INDESIT company

Model type:
DSG573NX

Commercial code:
F068586

n4513g02: INTRODUCTION OF NEW SYNCHRONOUS MOTOR

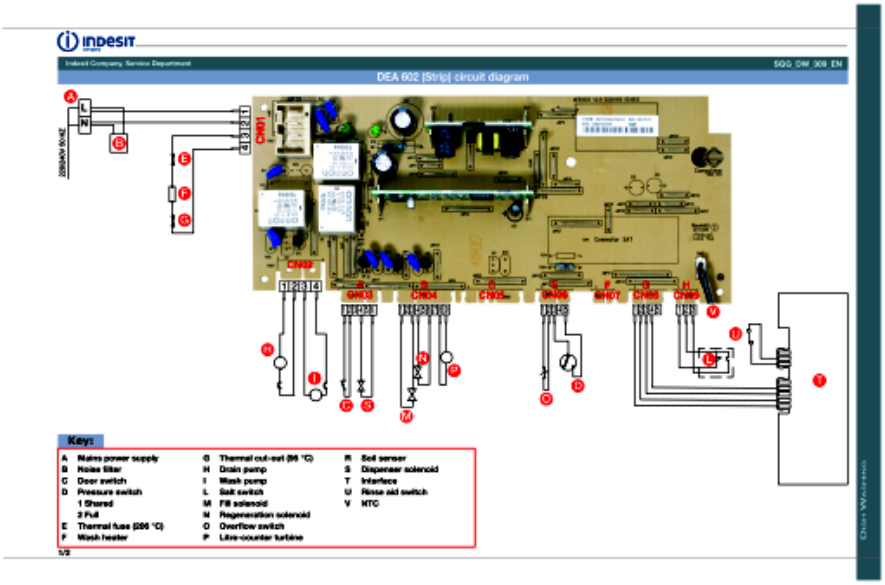
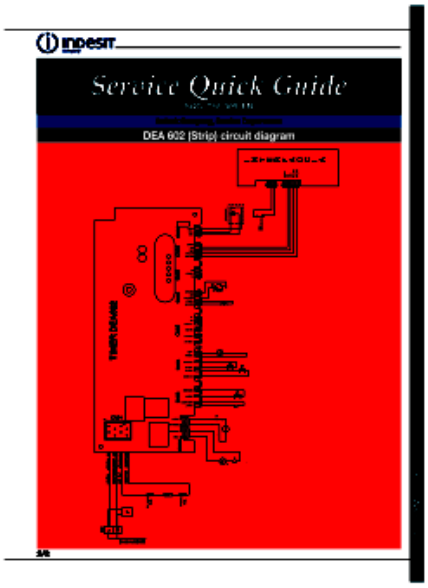
A new electropump has been introduced in the synchronous motor. This is perfectly interchangeable with the previous one, only the dowel has been modified improving its quality.

New motors have new codes:

Old New
C00256523 -> C00302800
C00256525 -> C00302798
C00272798 -> C00302796
